NOTICE FOR NASCAR Deluxe Games

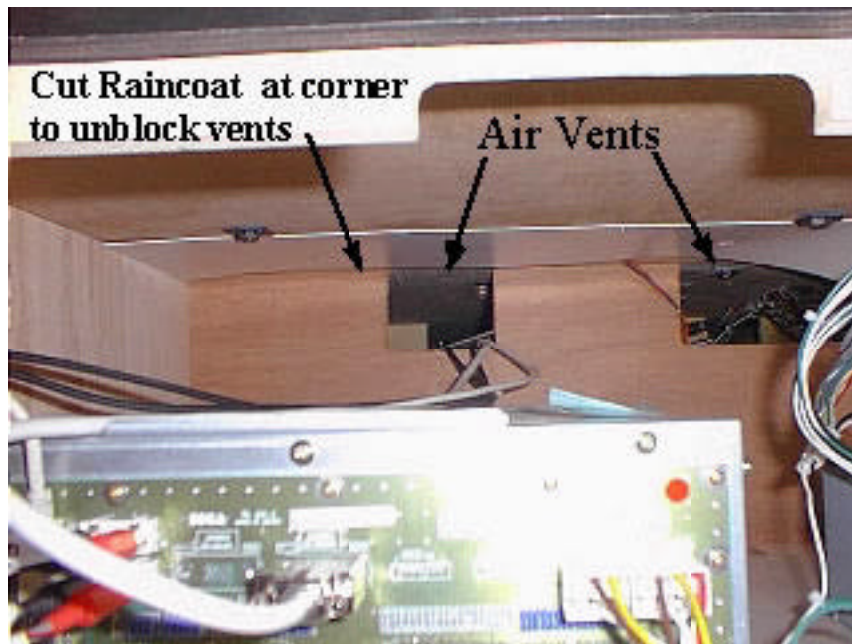
PROBLEM: Heat building up in the CPU area is causing the Game to Freeze. The Raincoat installed on the roof of the CPU area may be blocking the Vent holes.

SOLUTION: Please ensure you perform Bulletin 126 first, (Ensure Fan in Right rear of cabinet is installed and hole is cut in Wood). Remove back CPU access door, look at rear wall to see if Raincoat is blocking two vent holes at the top to the wall rear. If vent holes are not clear, carefully trim raincoat at corner of top and back wall. (See Picture Below) You may need to staple raincoat on back edge to ensure the vents are not blocked.
